# Memorandum

TO: Queensland Floods Commission of Inquiry  
FROM: Mark Babister  
DATE: 7 October 2011  
SUBJECT: Response to Peer Reviews of WMAwater's *Brisbane River 2011 Flood Event - Flood Frequency Analysis* (Sept 2011)  
PROJECT NUMBER: 111024

Figure 3: Port Office- Pre and Post dam flow

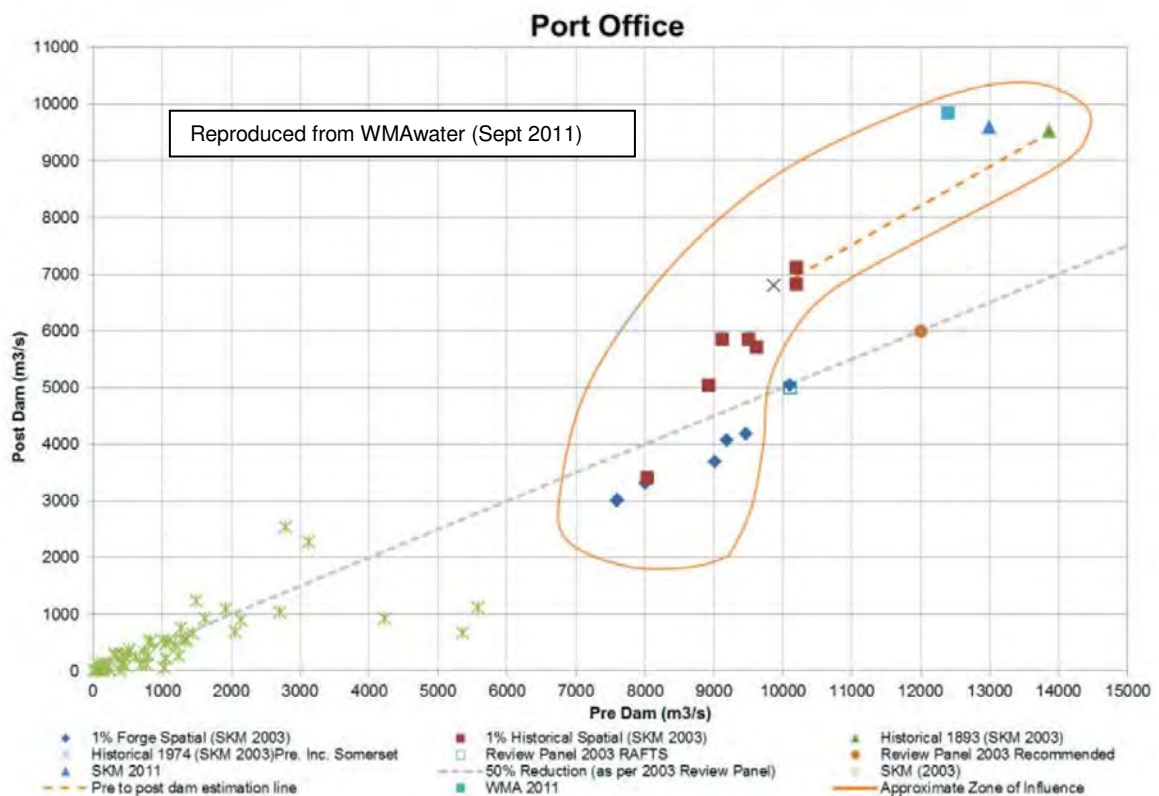
**Review the appropriateness of Figure 3 (page 15, WMAwater report) and the use to which it has been put within the report.**

- 11. Figure 3 contains a "pre to post dam estimation line" prepared by WMAwater. A copy of Figure 3 has been reproduced below.

- 12. This estimation line was used by WMAwater to convert their pre-dams 1% AEP discharge estimate of 13,000m<sup>3</sup>/s to a post-dams discharge of 9,000m<sup>3</sup>/s (without the influence of the 2011 event). It was also used (together with 2011 flood data) to estimate the post-dams discharge of 9,500m<sup>3</sup>/s (assuming knowledge of the 2011 flood). It is therefore a vital component of WMAwater's process for the determination of 1% AEP flows at the Port Office gauge.
- 13. The procedure used by WMAwater to prepare this line has not been explained in their report. The line appears to be either:

Figure 2: Inflow vs Outflow Wivenhoe Dam

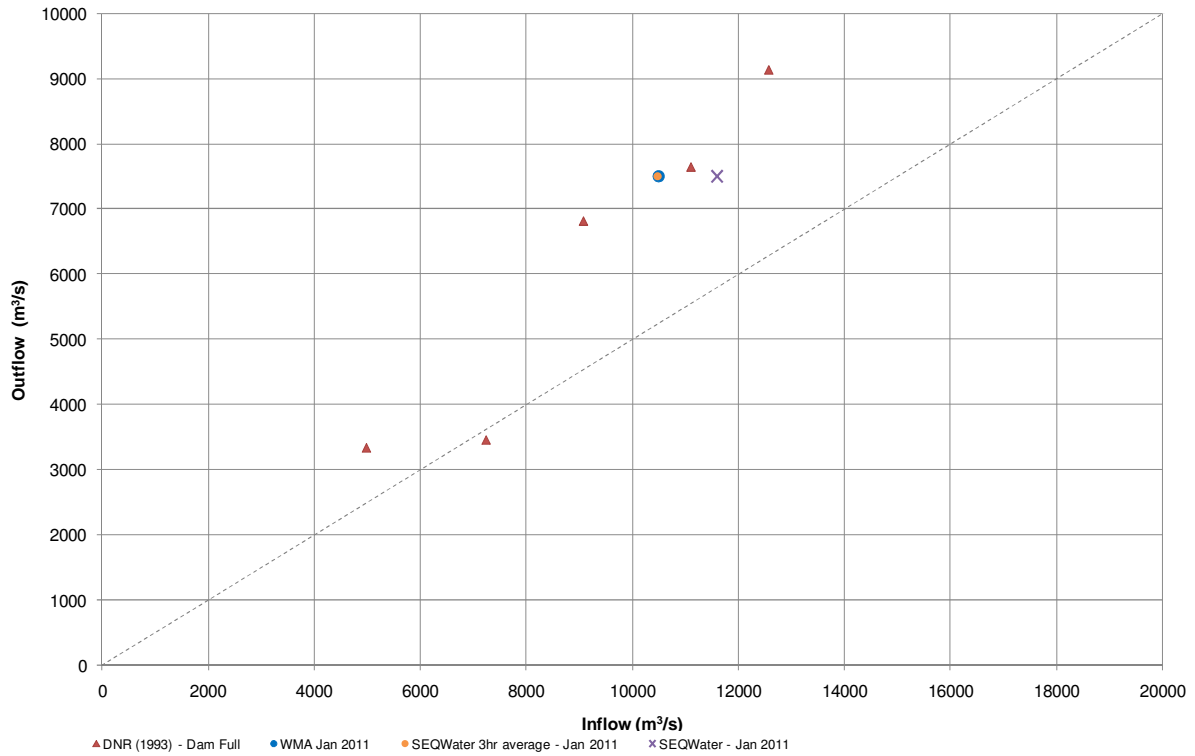
**63** “Figure 2 compares peak inflow and outflow for Wivenhoe dam from a number of sources for occasions when the dam is full. Also plotted on the graph is the 1:1 line (*or 50% reduction in flow by the dam as recommended by the 2003 Review Panel (Reference 20)*). While there is considerable scatter amongst the data points the graph shows below an inflow of 6000 - 8000 m<sup>3</sup>/s the attenuation is quite high while around 12000 m<sup>3</sup>/s the attenuation is quite low. It is not unexpected that there would be some scatter as two floods could have a similar peak inflow and very different volumes and hydrograph shapes. There is however a reasonable correlation of volume and peak flow. For peak outflows up to 4000 m<sup>3</sup>/s (max discharge allowed at Moggill under W3) the discharge is very dependent on the flow occurring in the Lockyer and Bremer Systems.” (Italics added)

Whatever ratio may be appropriate as the estimate of the attenuation for the 1% AEP design flood peak inflow to Wivenhoe Dam, it is fundamentally incorrect to use that ratio as applying to all magnitudes of inflow peaks, as is implied by the straight line plotted in Figure 2 of the WMAwater report. In fact, the magnitude of the **inflow volume** is of much greater significance than is the peak inflow rate. For floods with an inflow volume less than the flood storage compartment available, 100% attenuation can be achieved if so desired, regardless of the magnitude of the peak inflow rate. As the flood inflow volume becomes larger than the flood storage compartment available, the amount of attenuation of the peak flow that can be achieved will reduce but it will also depend on the dam operation strategy. For very rare flood events that are very much larger than that for which the dam was designed, the amount of attenuation will be very much reduced, though there will always be some attenuation because of storage volume resulting from rising flood levels upstream from the dam.

Figure 3: Port Office- Pre and Post dam flow

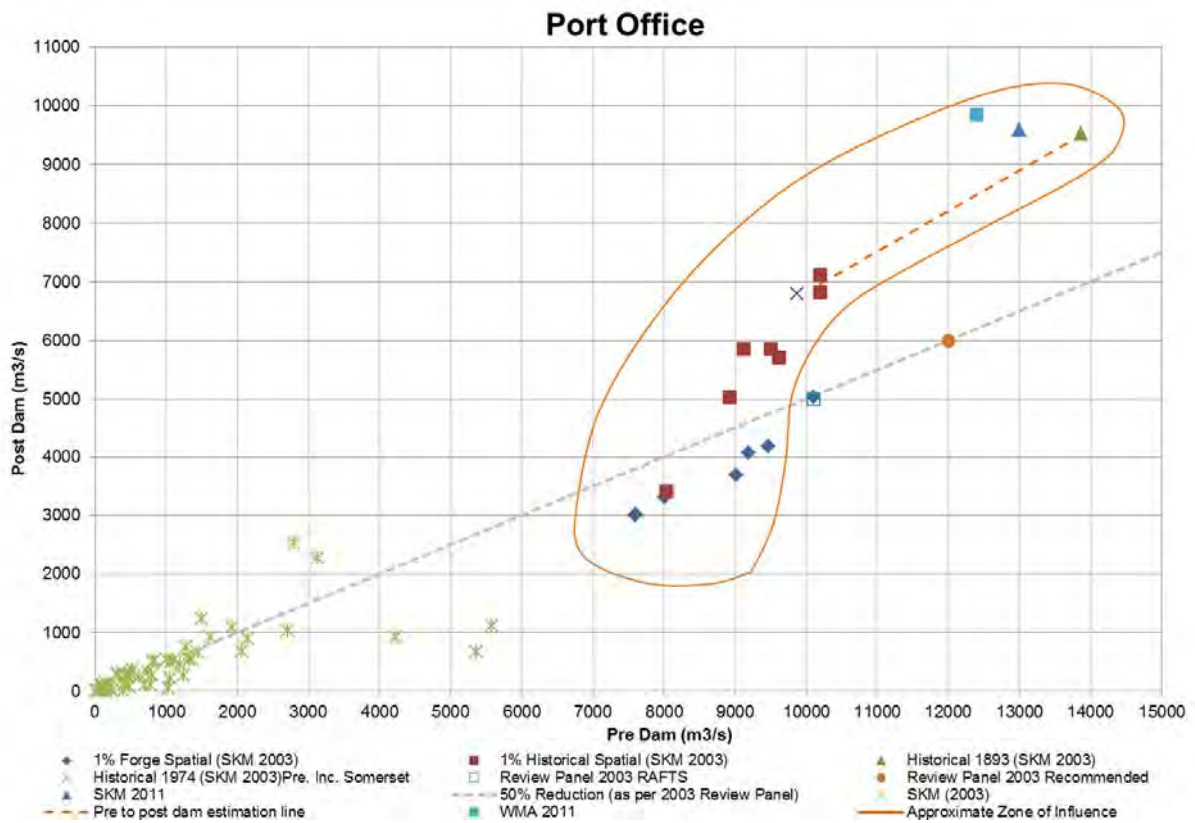
15. Some of "1% Historical Spatial" data on Figure 3 do not appear to be plotted in the correct position. The data likely originates from the "*critical flows*" presented in Appendix H of SKM (2003) for the seven historical spatial patterns considered by SKM. For some of the seven patterns however the data plotted are for different storm durations. Thus the pre-dam and post-dam discharges do not correspond to the same catchment event.

18. There is considerable scatter in the data points on Figure 3. Floods come in all shapes and sizes. If all of them were plotted the scatter would likely be much wider than that shown. Floods that have more volume for a given pre-dam discharge will likely plot higher on the figure than those with a lower volume for the same discharge as these are subject to less attenuation by the dams. A range of attenuations is possible.

- A plot of peak flows at the Port Office/City Gauge versus peak flows for the No Dams case is constructed, Figure 3 (see Note c).
- The ‘relationship’ in this plot is used directly to derive the estimate of the 1% AEP flood at the Port Office/City Gauge, 9500 m<sup>3</sup>/s, as a ratio of the 1% AEP flood at the Port Office/City Gauge for the No Dams case (see Note d).

- c. It is not clear how Figure 3 was created. The plotted points are somewhat scattered. The data point identified as „SKM 2011’ presumably was produced with the faulty Version 1 of MIKE11 since the only references for 2011 listed for SKM are No 35 (24 June 2011) and No 36 (11 March 2011), whereas the review that led to the production of the improved Version 2 of MIKE11 was carried out between 27 June and 5 July 2011 as described in the WMAwater report ‘*Review of Hydraulic Modelling Final Report 28 July 2011*’.

- It appears that no FFA has been undertaken for the current river conditions (with Wivenhoe and Somerset dams). Yet, an ARI for the January 2011 flood and a 100 year ARI discharge have been estimated for current river conditions. The basis for these estimates or justification for the adopted values is not adequately discussed in the WMAwater report.
- There is a heavy reliance on the accuracy of Figure 3 of the WMAwater report to explain and justify some of the study results and findings. Yet, there is no explanation about the data used to produce this figure and how the 'pre to post dam estimation line' has been developed. There

are several reasons why the inferences made from Figure 3 may be inaccurate and may significantly overestimate post-dams peak discharge at the Port Office, including:

- The January 2011 flood had two peaks with the first flood peak inflow to the Wivenhoe and Somerset dams of the order of 12,000 m<sup>3</sup>/s, whereas the corresponding peak discharge at the Port Office gauge for the first flood was only of the order of 2,000 m<sup>3</sup>/s, a more than 80% reduction. This reduction in peak discharge at the Port office for the first flood event is not represented in Figure 3.

- The February 1999 flood was larger than the 1974 flood in the upper Brisbane River, but its impact on Brisbane was insignificant because this flood was fully mitigated by the dams (Seqwater, 2011). The peak flood level at the Port Office gauge was less than 1.7m AHD. The 1999 flood event is not represented in Figure 3.

- 8 While we thought that Figures 2 – 5 (Reference 9) and the associated text, on the pre to post dam relationship were largely self explanatory we accept the reviewer comment that more explanation was required.

- 9 The intent of these figures was to demonstrate the variability of pre dam to post dam flows and that there is no fixed ratio as this will vary from one event to the next. It was for this reason that the approximate zone of influence (solid orange line) was drawn around these values. The key aspect of Figures 2 – 5 (Reference 9) is that they include the best estimates of 1893, 1974 and 2011 events, as well as a number of synthetic (design) events. An updated version of Figure 3 is attached which includes a range of plausible adjustments for the impact of Somerset dam. It also shows the most likely zone of influence based on the scatter of the data points.

- 10 Figure 2 mainly contains Seqwater (Reference 12) and DNR data, while nearly all the points on Figures 3 - 5 were extracted from modelling work carried out by SKM (Reference 6). Even though Figure 2 is derived from different data sets it has a very similar shape to Figures 3 - 5.

- 13 The 3 historical events (1893, 1974 and 2011) on Figure 3 are described by Dr Nathan as a “miserably small” dataset, they show a dam performance which is very different from the 2003 Review Panels 12 000 m<sup>3</sup>/s pre dam to 6000 m<sup>3</sup>/s post dam (Reference 5) and SKM (2003) 12 000 m<sup>3</sup>/s pre dam to 6500 m<sup>3</sup>/s post dam and all 3 events are larger than 6500 m<sup>3</sup>/s. This raises serious concerns about the 2003 pre to post dam conversion as not one historical event supports it and it is hard to accept all 3 events are outliers.

Figure 8: Port Office Rating for Current Conditions

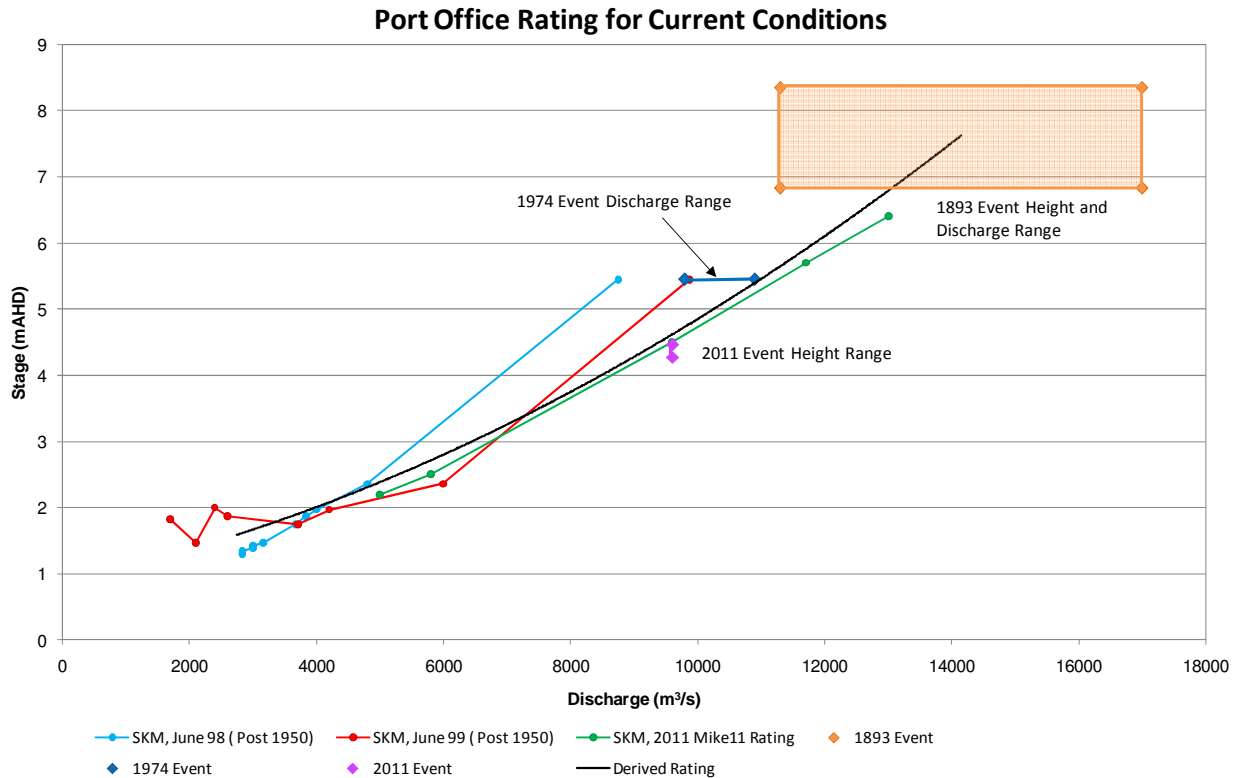
- (e) the results of this analysis could produce discharge estimates somewhat different from that currently used. For example by reference to WMAwater's Figure 8, a 1.0m change in height would produce discharge changes of from 1,500 m<sup>3</sup>/s to 2,500m<sup>3</sup>/s over the range of interest (i.e. stage heights ranging from 8mAHD to 2mAHD). These are significant discharge changes which could noticeably alter the flood frequency results and the prediction of the 1% AEP discharge.

31. The flood series used by WMAwater disregarded flows lower than  $2,000\text{m}^3/\text{s}$ .<sup>10</sup> From the 'derived rating' curve in their Figure 8, this flow corresponds to a level of 1.4mAHD. Very considerable tidal influences would likely be present at this level.

36. There are six data items included in WMAwater's Figure 8 which are discussed below. (The first two are listed under Item a):
  - (a) *SKM (June 1998)* and *SKM (June 1998)* – these appear to be based on recorded levels from historical floods with flows estimated from the MIKE11 models used in those studies - but I can't be sure;

- (b) *SKM (2011)* – appears to be obtained directly from the MIKE11 model noting that this model was calibrated to the 2011 flood records;
  - (c) *1893 Event* – the orange box on Figure 8 is based on flood heights ranging from 8.35mAHD to 6.83mAHD.<sup>12</sup> The discharge range is 11,300m<sup>3</sup>/s to 16,900m<sup>3</sup>/s.<sup>13</sup> As discussed in the footnotes, the most likely estimate of the 1893 event is 6.83mAHD and 11,600m<sup>3</sup>/s – so the orange box should be centred on this point (which approximates the lower left hand corner of the existing box).

38. Whatever the reason, to use the 'derived rating' on Figure 8 to estimate all the historical discharges (i.e. for use in the flood frequency analysis) does not seem appropriate and must introduce further uncertainties into the analysis which is subsequently presented by WMAwater in their Section 7.<sup>14</sup>
39. A likely consequence will be that the discharges used in the flood frequency analysis are over estimated, including the discharge estimate of the resultant 1% AEP event.

A new rating curve derived in the study (see Figure 8 of the WMAwater report) has been adopted for the Port Office gauge to convert recorded peak flood levels into peak discharges for use in the FFA. There are some uncertainties with this new rating curve. For example, the recorded peak flood level at the Port Office gauge for the January 2011 flood does not fit the derived rating curve. In addition, based on the shape of the January 2011 recorded water level hydrograph, the tidal influence appears to have affected flood levels at the Port Office gauge at least up to discharges of 9,500 m<sup>3</sup>/s (Seqwater, 2011). Tidal influences are not taken into account in the adopted rating curve.
